Re: Individual Section 404 updated Permit Application Materials
Derry-Londonderry, 13065 (Exit 4A)

RESPONSE TO NHDES REQUEST FOR MORE INFORMATION
NHDES # 2018-03134

TROLLEY CAR LANE STREAM RELOCATION
LONDONDERRY, NEW HAMPSHIRE

Map 1. Diagram showing locations of the cross sections (red lines), vegetation plots (orange boxes) within the monitoring reach at Trolley Car Lane Stream, Londonderry, New Hampshire.

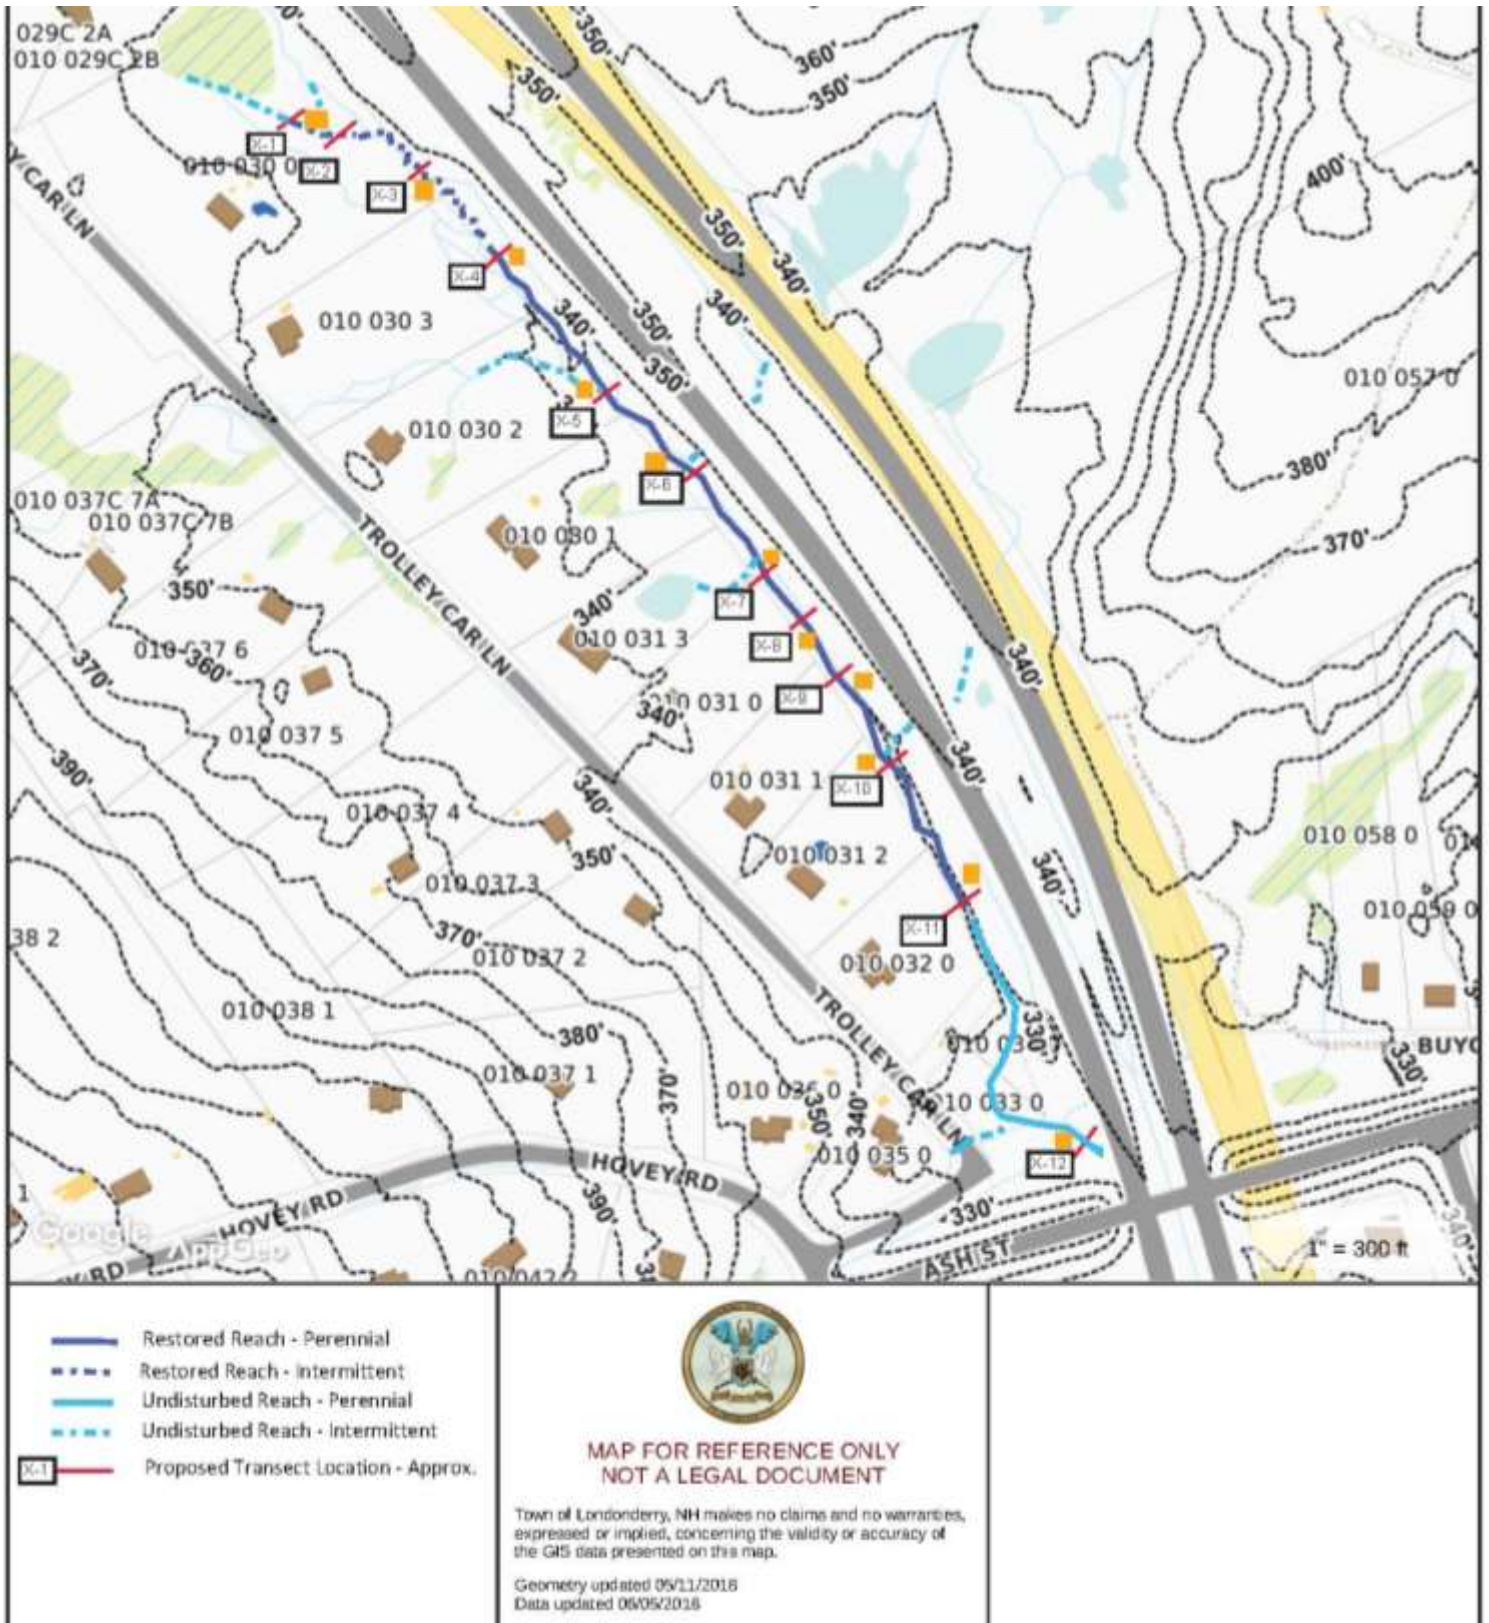
NHDES has also requested a Trolley Car Lane **Stream Restoration/Re-establishment Monitoring Plan**.

The monitored cross sections were selected based on the engineers designed grade controls in the existing plan set. These locations will be used together to provide information on the project restoration's goal of a stable channel elevation in the restored reach. The cross-sections will be georeferenced (post-construction), flagged, and mapped for monitoring consistency (Map 1). Several of the monitoring parameters, such as sediment distribution, photo stations, and longitudinal profile data, will be evaluated at each cross-section for long-term observations of change. Once established, these cross-section locations will not change. Preliminary visual assessments will be made prior to initiating construction and use of spatial imaging (such as LiDAR or aerial photos) will be used to aid in long term review of the channel changes. Channel and bank features will be collected as part of the monitoring protocol at established cross-sections. The following data will be observed and recorded: areas of aggradation, bed scour, bank erosion, and changes to installed structures (i.e. bioengineering materials, wood additions, rock weirs, grade control stones, and constructed step-pools). Cross-section measurements within the project reach will include floodplain width, bankfull width, wetted width, and water surface elevations/depths.

One longitudinal profile (long-pro) will be created as part of this monitoring plan. The long-pro will extend the entire length of the monitoring area which is approximately 1,800, including the relocated channel and the immediately upstream reach. Beginning immediately below where stream flow was diverted for construction, the long-pro monitoring will primarily collect thalweg elevations but also include newly developed instream features such as riffles, boulder constrictions, and large pools. Additional measurements, concentrated at established cross-sections, will include areas of interest such as depositional features and downstream scour at grade control features to observe changes in channel geometry. Newly formed habitat features (i.e. pools, riffles, and runs) will be documented, as well as instream habitat structures such as log jams, downed trees, and newly entrained large boulders.

Photos should be taken from the **same locations** for each monitoring event and included on the site map. Take repeated photos at these locations: 1) all downstream gradient structures (rock weirs/vanes and step-pools, if designed), 2) across the stream channel from right bank to left bank at each cross section 3) views of the stream channel directly upstream 4) views of the stream channel directly downstream 4) erosion control structures and 9) areas of the floodplain where plantings were done. Photos may be included in an appendix, submitted as a separate file, or in the text to correspond with the data for each parameter.

TROLLEY CAR LANE STREAM PROFILE

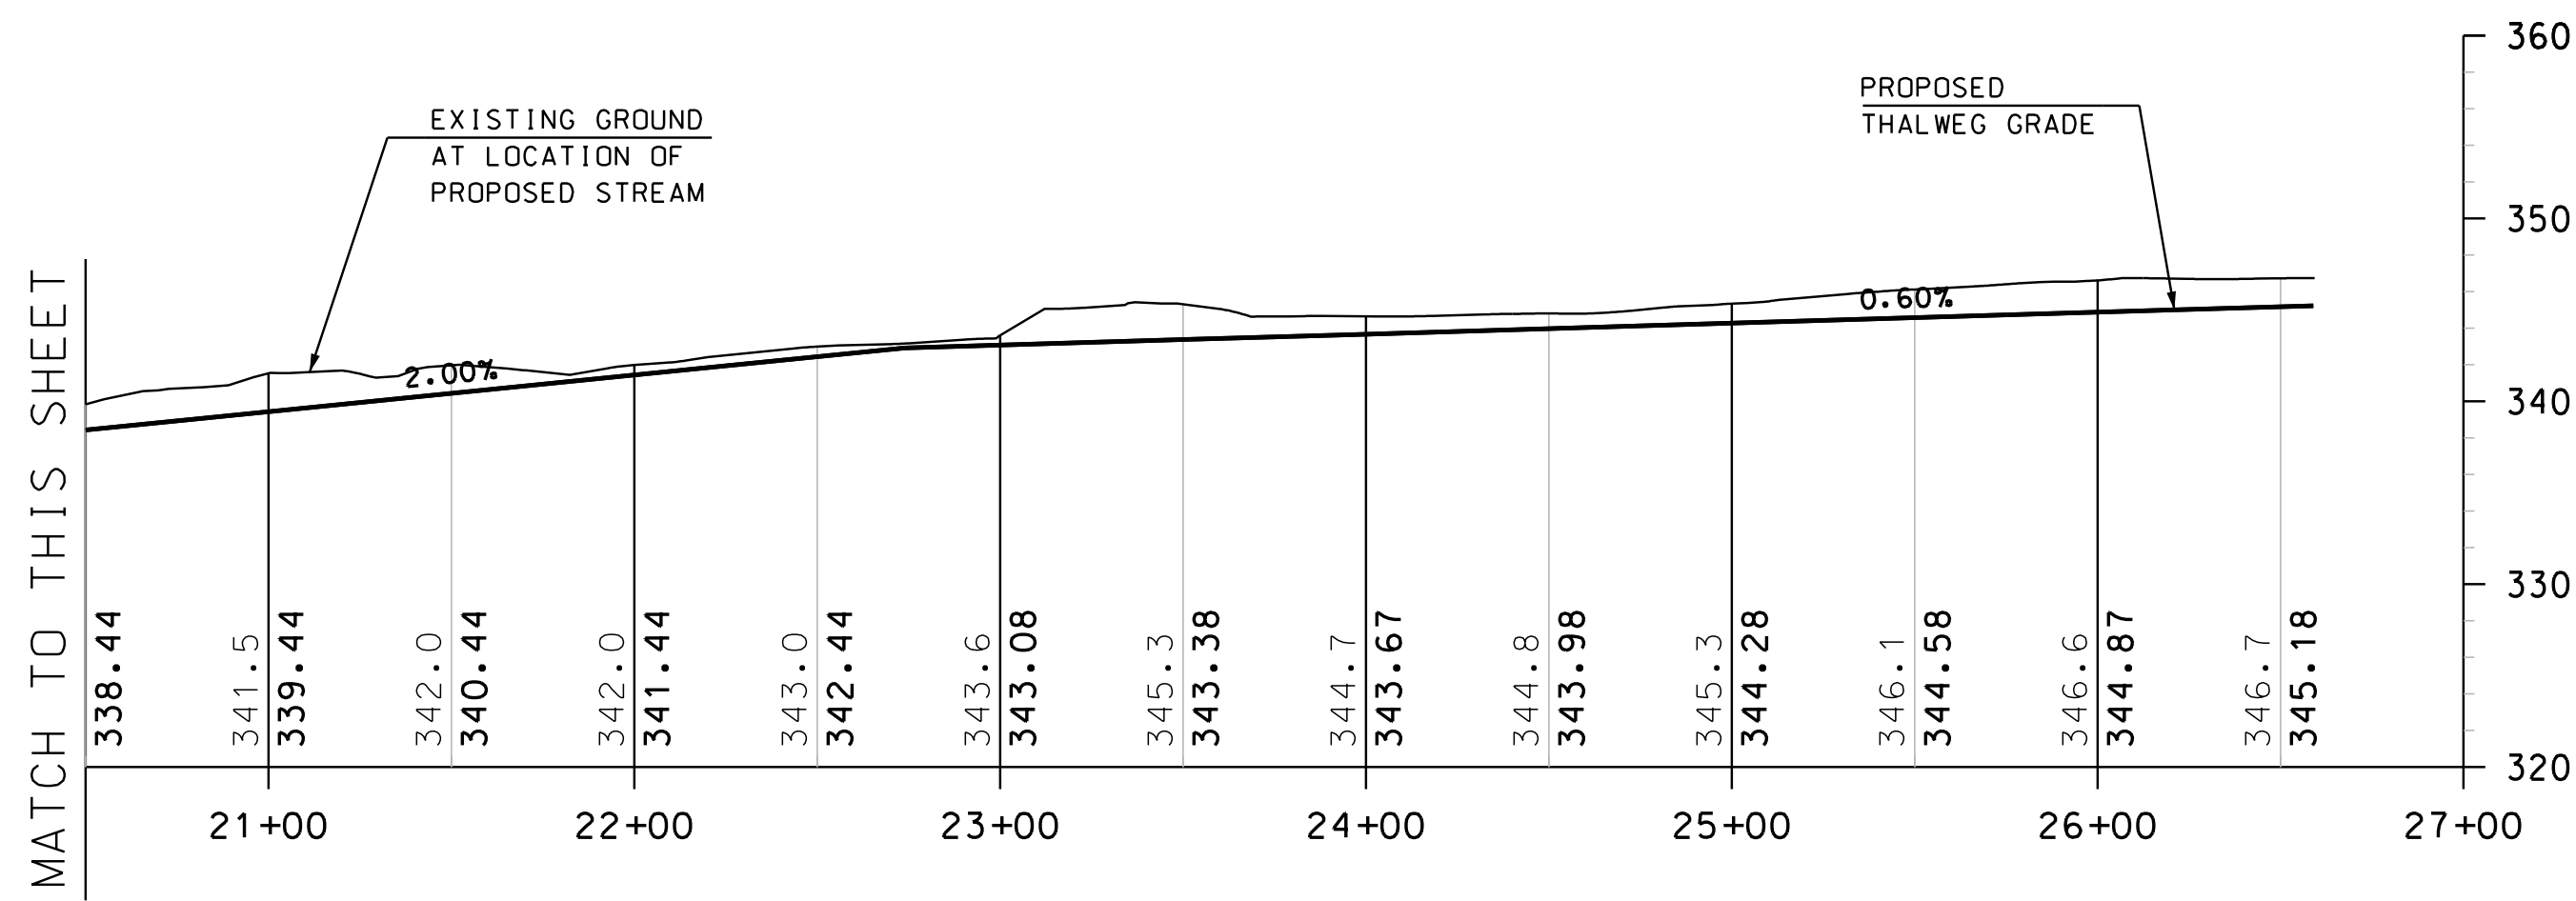
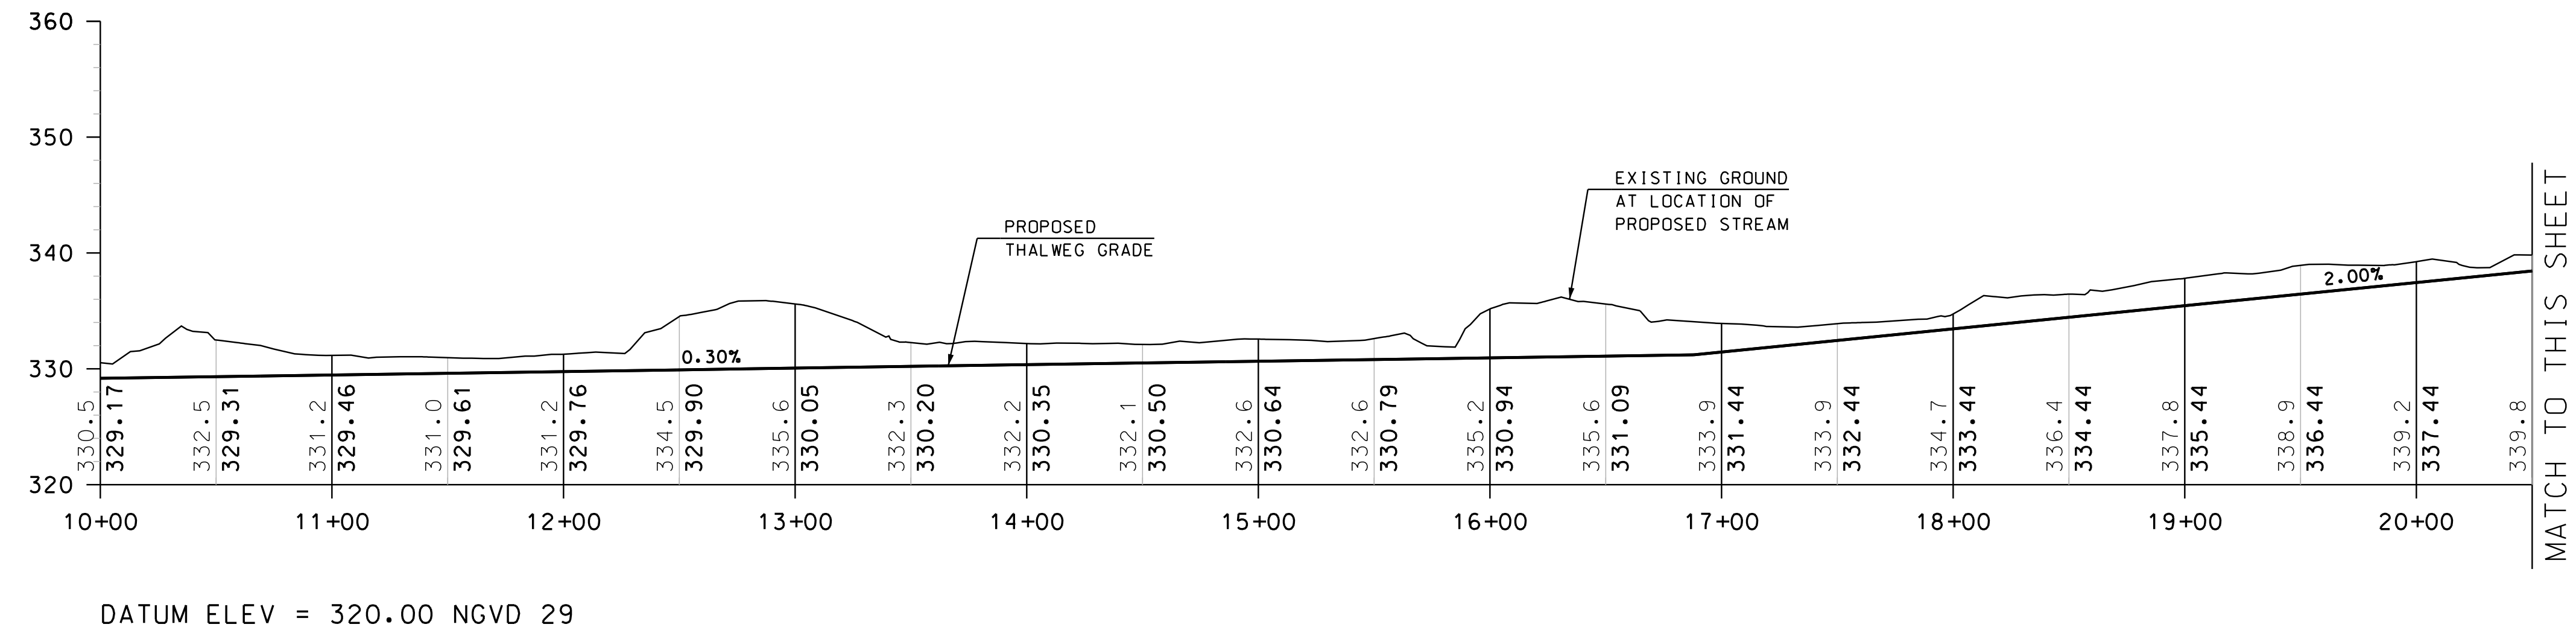
This agreement is also dependent on **stream restoration design and plans**, which are being submitted with this RFMI response. NHDES has requested that the stream channel reconstruction design address the following elements:

- Bank full width
- Entrenchment Ratio
- Sinuosity
- Net floodplain
- Existing forested buffer
- Native planting plan
- Stream bed simulation material
- Longitudinal profile and grading plan
- Accommodate perpendicular tributary flows to Trolley Car stream
- Accommodate for any increased flow volume due to additional impervious (BFW/ER)
- Methodology of stream reconstruction

Longitudinal profile and cross-section plan

Table 3 (Table 3-1 Revised) below has been modified to include the proposed channel morphology and compares the proposed stream restoration design to the stream morphological parameters in Normandeau’s Table 3-1 from the 2010 stream assessment report. The northern (intermittent) reach of designed Stream S1 (Station 23+52 to 26+59) is designed to meet the morphological conditions of the existing middle intermittent stream channel reach in Table 3-1 to the extent possible. The portion of Wetland 14 through which this reach is currently dispersed in braided sections will be partially filled for the construction of the Exit 4A ramps, so the intermittent stream channel will be confined to one channel. Meanders are designed to replace sinuosity to the extent possible within the available construction area. The southern (perennial) portion of the designed stream (Station 17+70 to 23+52) compares to the observed lower perennial stream channel reach in Table 3-1. The lowest portion of the designed channel (Station 10+00 to 17+70) was not included in the original study and was therefore not included in the Table 3. This section of the channel was designed to match the existing morphological characteristics as taken from survey and recent site reconnaissance.
